City of Ketchum

Recommendation to hold a public hearing, consider public input, and approve the Emery Lot Line Shift

A PRELIMINARY PLAT SHOWING EMERY SUBDIVISION

IN RE:)	
)	
Emery Lot Line Shift)	KETCHUM CITY COUNCIL
Lot Line Shift)	FINDINGS OF FACT, CONCLUSIONS OF LAW, AND
Date: December 7, 2020)	DECISION
)	
File Number: P20-066)

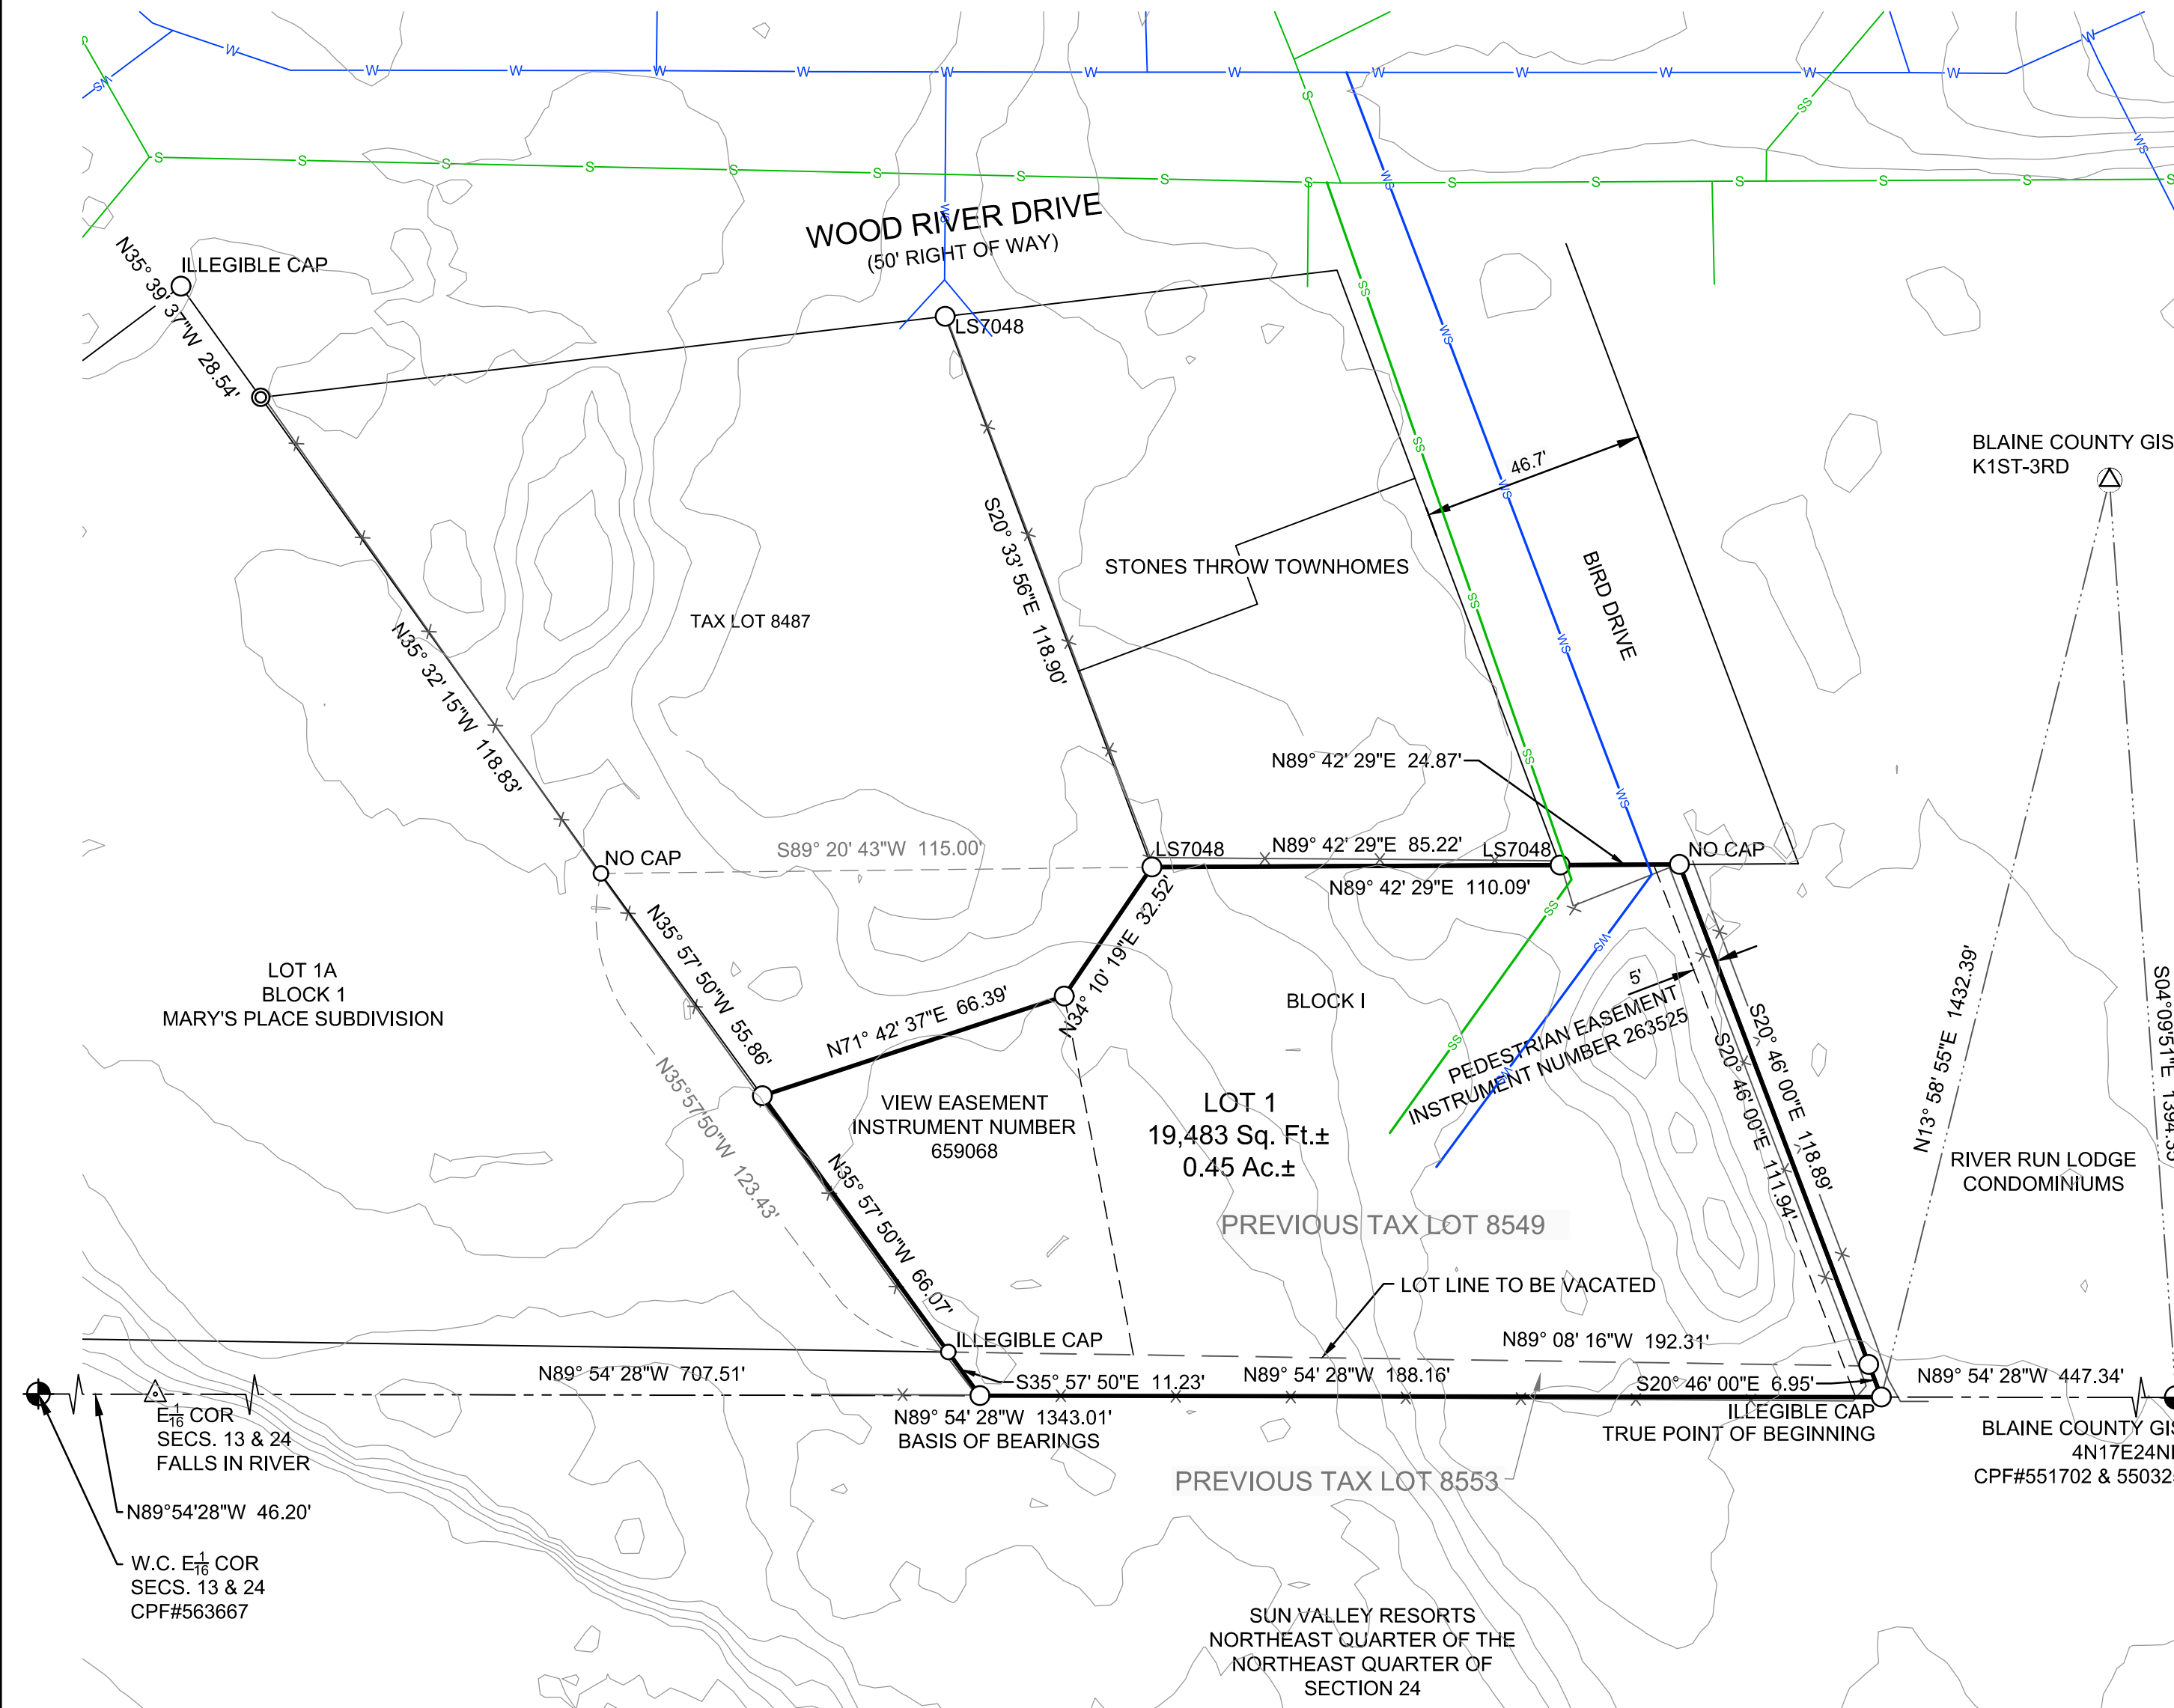
<input checked="" type="checkbox"/>	<input type="checkbox"/>	<input type="checkbox"/>	16.04.030.K.13	Certificate by registered engineer or surveyor preparing the map certifying to the accuracy of surveying plat. <i>As conditioned, this standard will be met prior to recordation of the Final Plat. The signature block page shall include the surveyor's certification.</i>
<input checked="" type="checkbox"/>	<input type="checkbox"/>	<input type="checkbox"/>	16.04.030.K.14	A current title report of all property contained within the plat. <i>This standard has been met. A title report and warranty deed were submitted with the Preliminary Plat and both are current.</i>
<input checked="" type="checkbox"/>	<input type="checkbox"/>	<input type="checkbox"/>	16.04.030.K.15	Certification of owner(s) of record and all holders of security interest(s) of record with regard to such property. <i>As conditioned, this standard will be met prior to recordation of the Final Plat. The signature block page shall include a certificate of ownership and associated acknowledgement from all owners and holders of security interest with regard to the subject property, which shall be signed following Ketchum City Council review and approval of the application and prior to recordation of the Final Plat.</i>

<input checked="" type="checkbox"/>	<input type="checkbox"/>	<input type="checkbox"/>	16.04.040.E	<p>Monumentation: Following completion of construction of the required improvements and prior to certification of completion by the city engineer, certain land survey monuments shall be reset or verified by the subdivider's engineer or surveyor to still be in place. These monuments shall have the size, shape, and type of material as shown on the subdivision plat. The monuments shall be located as follows:</p> <ol style="list-style-type: none"> 1. All angle points in the exterior boundary of the plat. 2. All street intersections, points within and adjacent to the final plat. 3. All street corner lines ending at boundary line of final plat. 4. All angle points and points of curves on all streets. 5. The point of beginning of the subdivision plat description. <p><i>This standard has been met. See Surveyor Narrative on page 1 of the plat.</i></p>

1. The instrument numbers associated with both Encroachment Agreements shall be referenced on the plat prior to the plat being recorded.
2. The recorded plat shall show a minimum of two Blaine County Survey Control Monuments with ties to the property and an inverse between the two monuments. The Survey Control Monuments shall be clearly identified on the face of the map.
